UNITED STATES PATENT AND TRADEMARK OFFICE

APPLICATION NO.	FILING DATE	FIRST NAMED INVENTOR	ATTORNEY DOCKET NO.	CONFIRMATION NO.
10/707,266	12/02/2003	Tomas Kalender	P7330.3US	1265
30008	7590	09/20/2005	EXAMINER	
GUDRUN E. HUCKETT DRAUDT LONSSTR. 53 WUPPERTAL, 42289 GERMANY			BAUER, SCOTT ALLEN	
			ART UNIT	PAPER NUMBER
			2836

Office Action Summary	Application No. 10/707,266	Applicant(s) KALENDER, TOMAS	
	Examiner Scott Bauer	Art Unit 2836

Fig-1

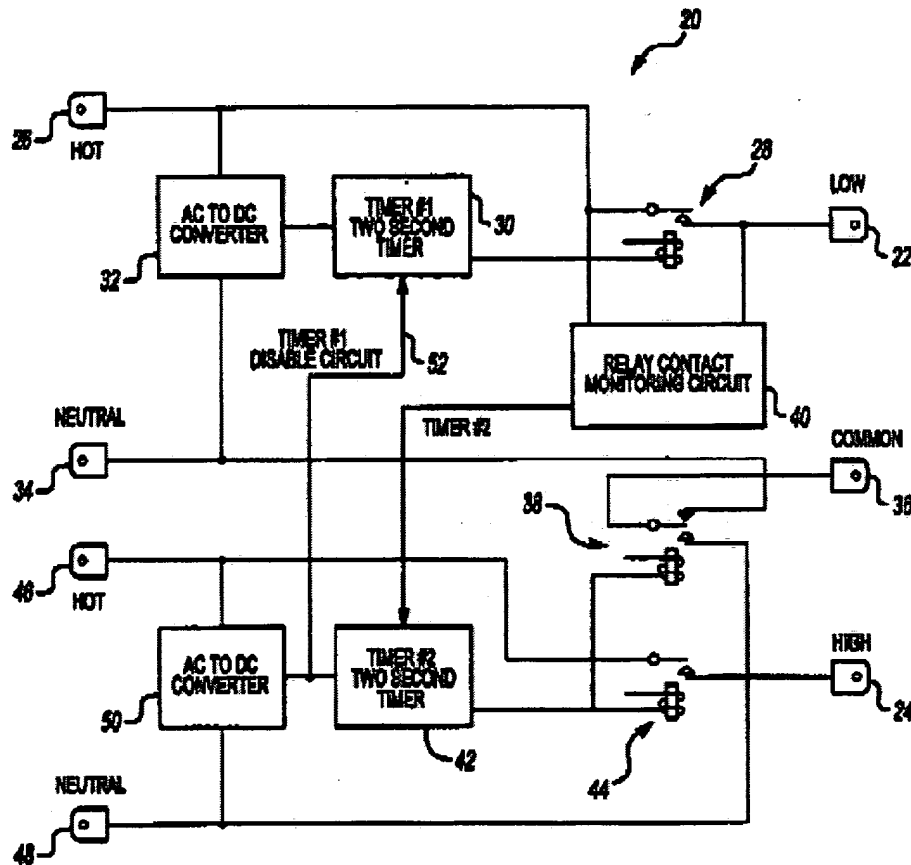
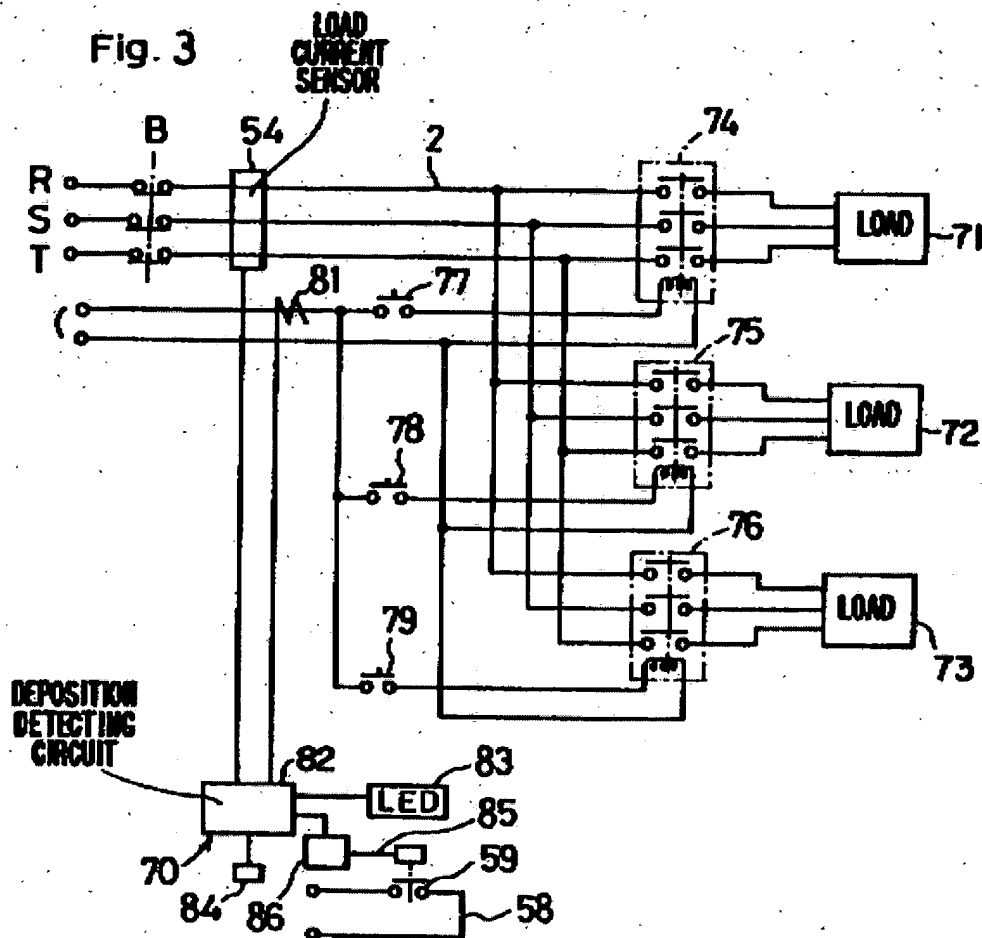
5. With regard to Claims 1 & 4, Naranjan et al. teaches a device that detects error and locking (20) of a switch (28) that sequentially connect motors (22) to a converter (32) that checks the switched-off state of a switch (28) before it sends switching signals to at least two switches (28 & 44) (column 2 lines 38-46). Naranjan also teaches connecting signal leads to the converter.

Naranjan et al. does not teach the monitoring of at least two switches. Umemura in Figure 3 teaches the use of a sensor to monitor the switched-off state of at least two switches prior to a switching action (column 5 lines 5-18).

It would have been obvious to one of ordinary skill in the art at the time the invention was made to combine the teachings of Naranjan et al. with Umemura for the purpose of detecting malfunctions of relays to systems with plural loads (column 5 lines 5-8).

6. With regard to Claim 5, the switches of Umemura are external switching devices. In the above mentioned device, for error detection and mutual locking of switches, the signal leads are connected via an external switching device to the converters as taught by Umemura. The external switching device receives the switching signals from the converter.
